W3F1-2000-0135
A4.05
PR

Subject: Waterford 3 SES
Docket No. 50-382
License No. NPF-38
Revision 4 to the Core Operating Limits Report for Cycle 10

CORE OPERATING LIMITS REPORT

REVISION 4

COLR Figure 2A

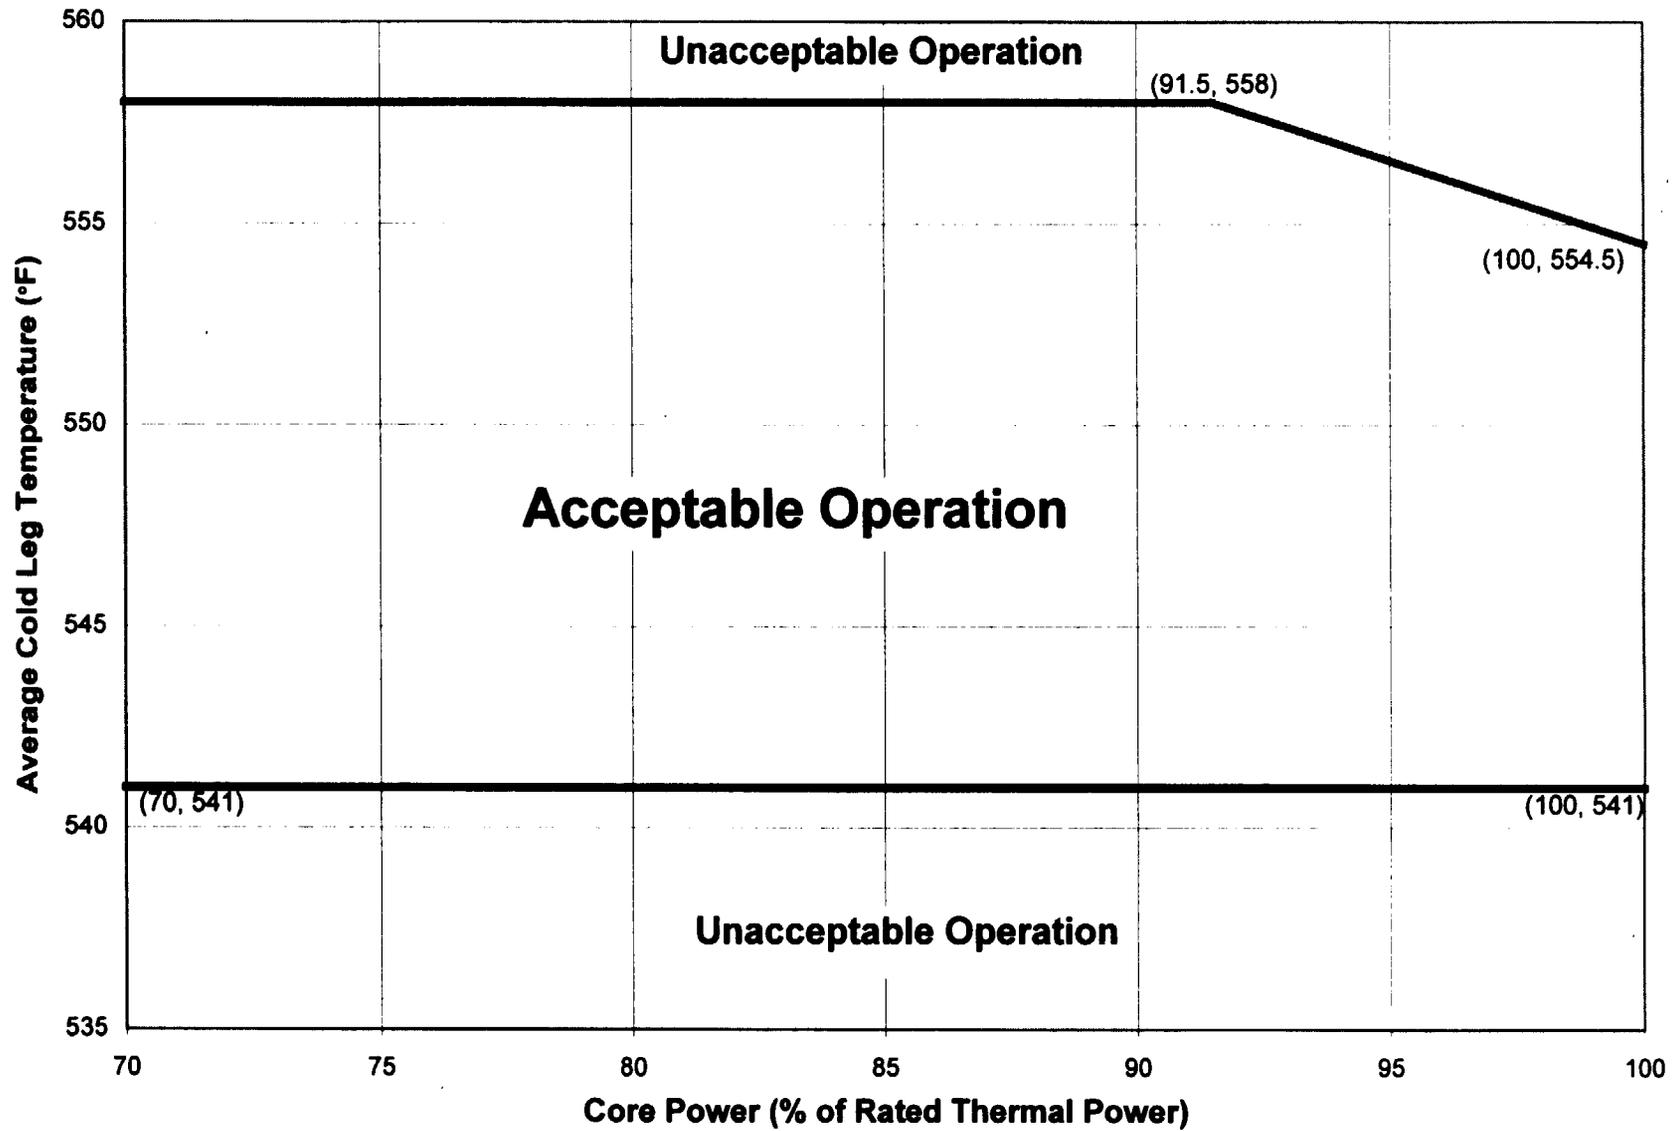
Revised section 3.1.1.3, Moderator Temperature Coefficient, and COLR Figures 2A, 2B, and 2C to reflect the changes to Critical Boron Concentration (CBC) due to continued depletion of the B-10 isotope. The effectiveness of the RCS boron as a poison is less than that assumed in the development of the COLR figures. For additional details, refer to Condition Report CR-WF3-2000-1061 and Engineering Request ER-W3-00-0753-00-00.

- With the Critical Boron Concentration (CBC) less than or equal to 153 ppm and greater than 111 ppm, the COLR Figure 2A cold leg temperature and power restrictions shall be maintained within the region of acceptable operation.
- With the CBC less than or equal to 111 ppm and greater than 56 ppm, the COLR Figure 2B cold leg temperature and power restrictions shall be maintained within the region of acceptable operation.
- With the CBC less than or equal to 56 ppm, the COLR Figure 2C cold leg temperature and power restrictions shall be maintained within the region of acceptable operation.

Cold Leg Temperature versus % of Rated Thermal Power
Critical Boron Concentration (CBC) Less than or Equal to 153 ppm and Greater than 111 ppm
(153 ppm \geq CBC > 111 ppm)
